City of Albuquerque

RE: DRAINAGE PLAN FOR CIRCLE K STORE NO. AB-25
(J-20/D28) RECEIVED OCTOBER 11, 1988

CIRCLE K STORE NO. AB-25
INDIAN SCHOOL & EUBANK BLVD. NE
ALBUQUERQUE, NEW MEXICO

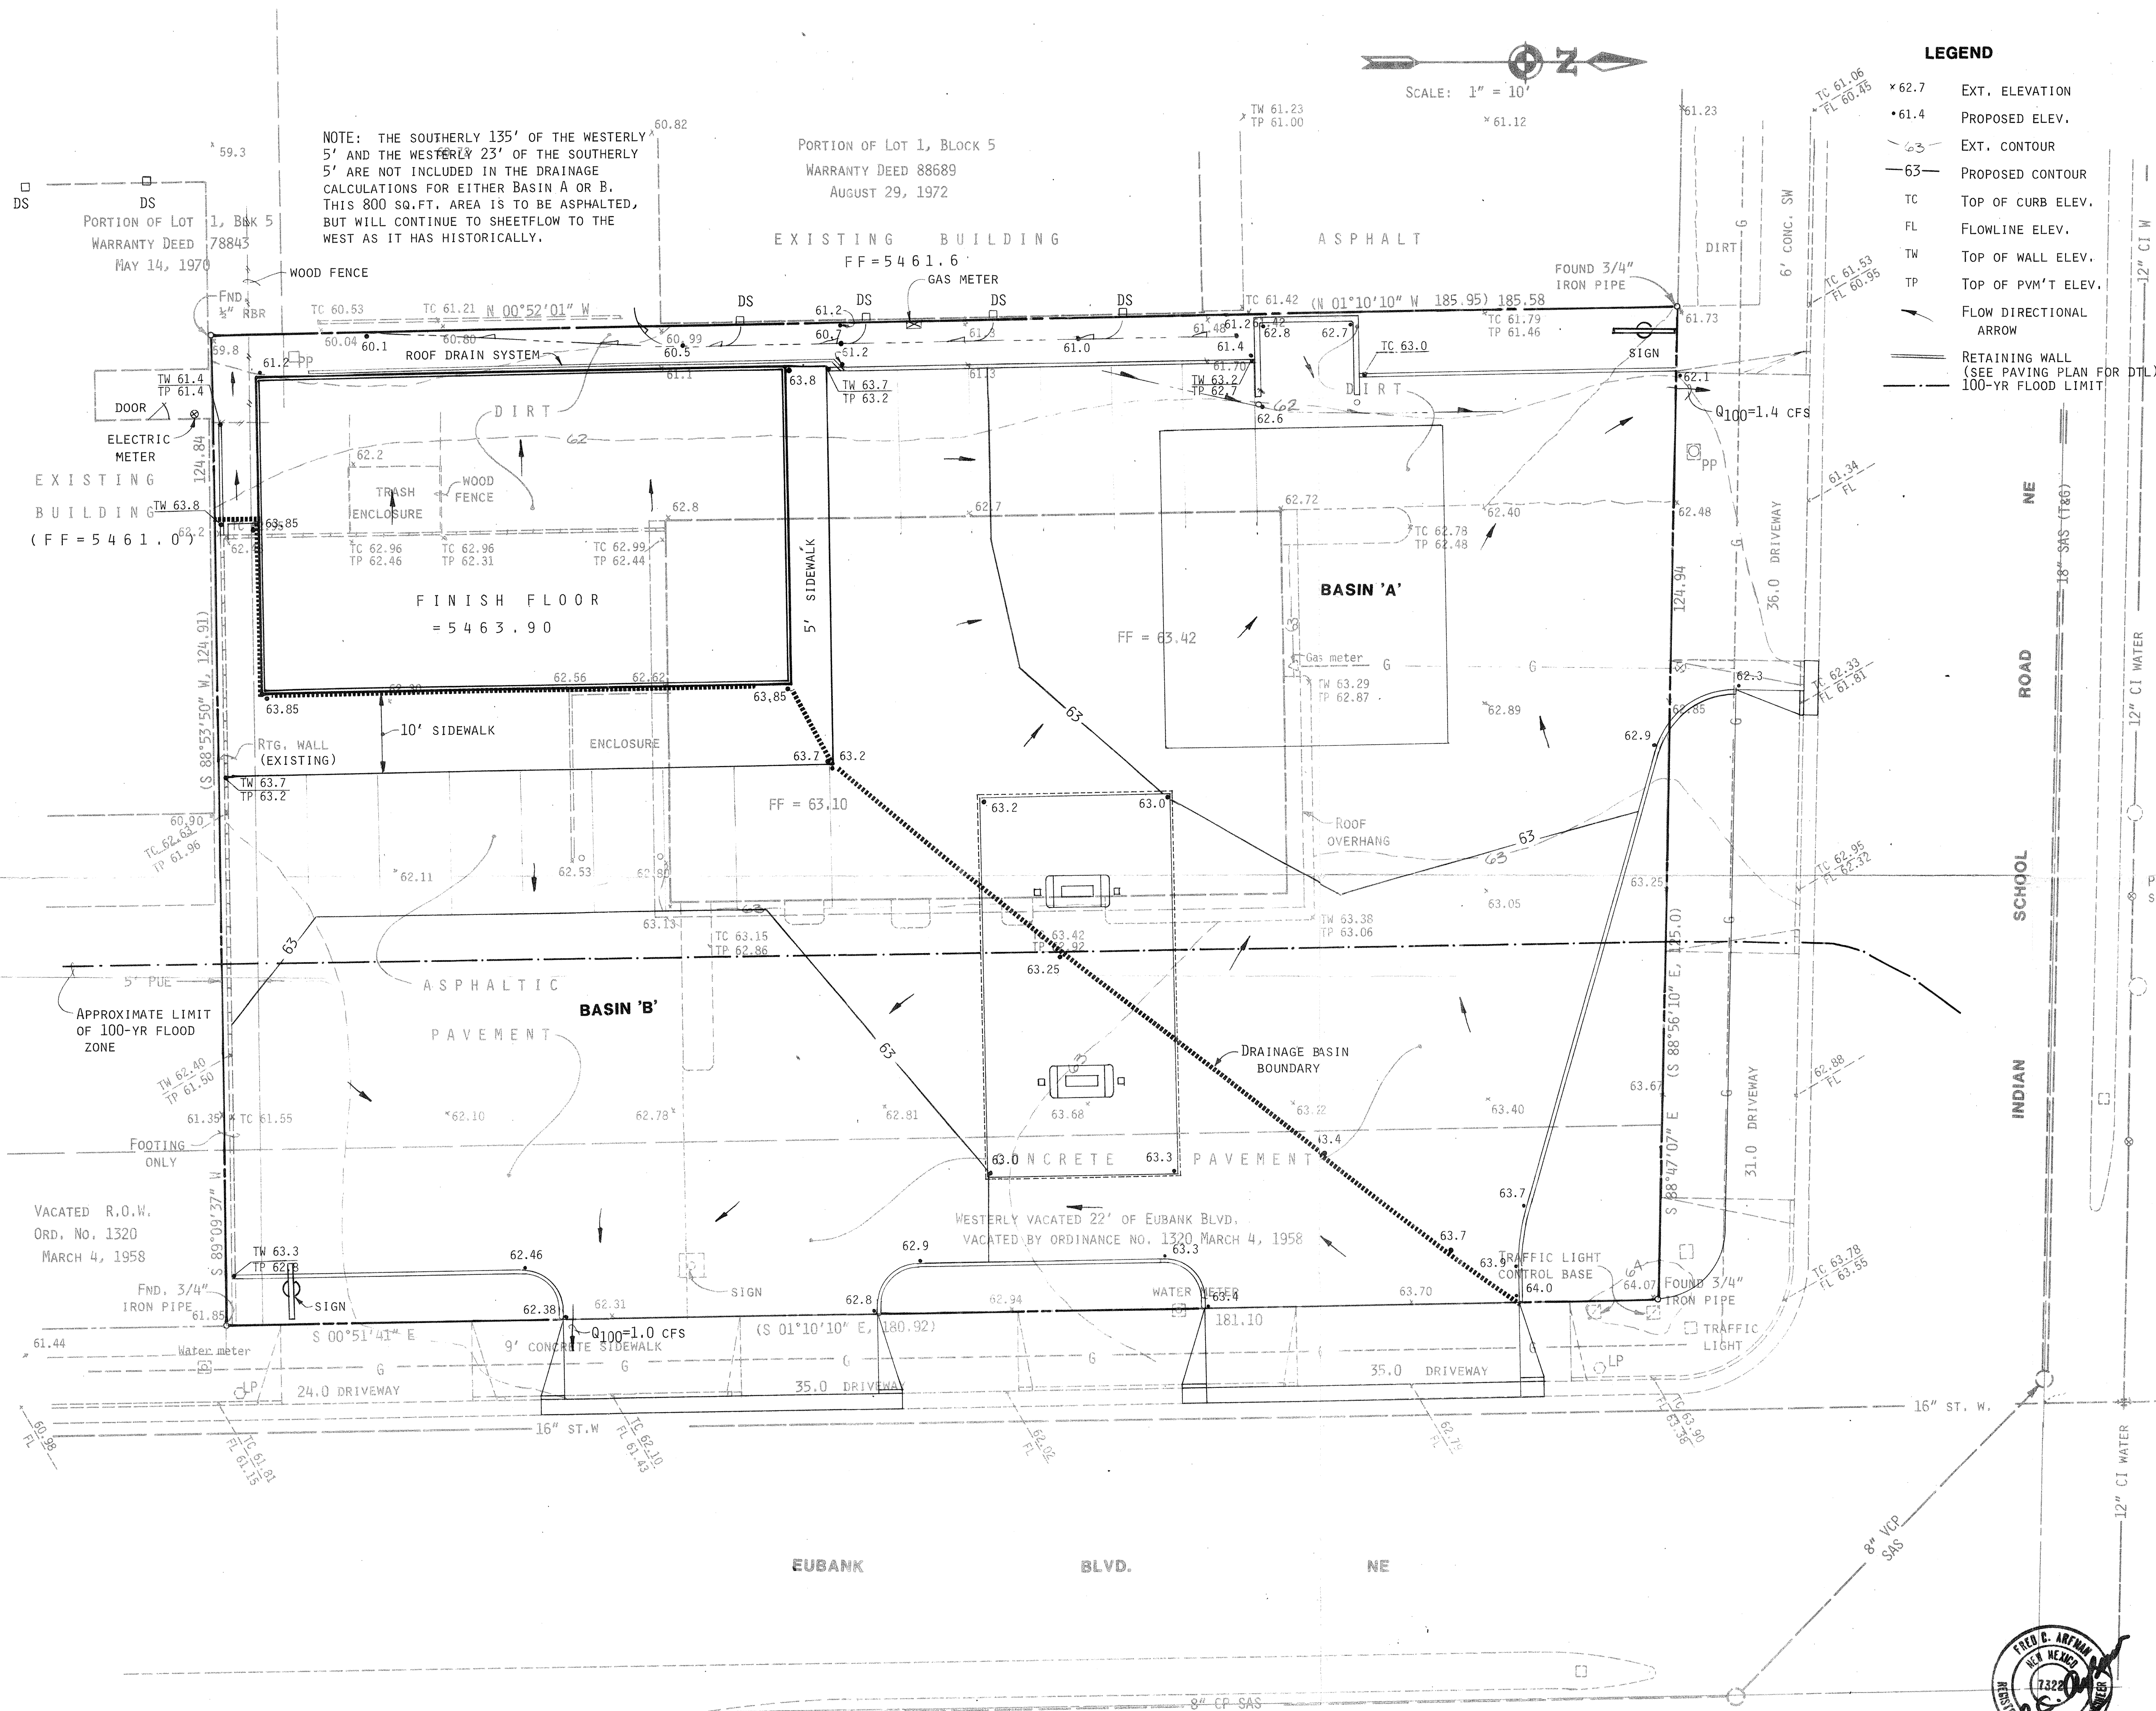
1. The only way that you would be allowed to drain the 800 sq. ft. area to its historical point is if you left the area pervious.
2. Please include a typical cross section of your proposed roof drain system.
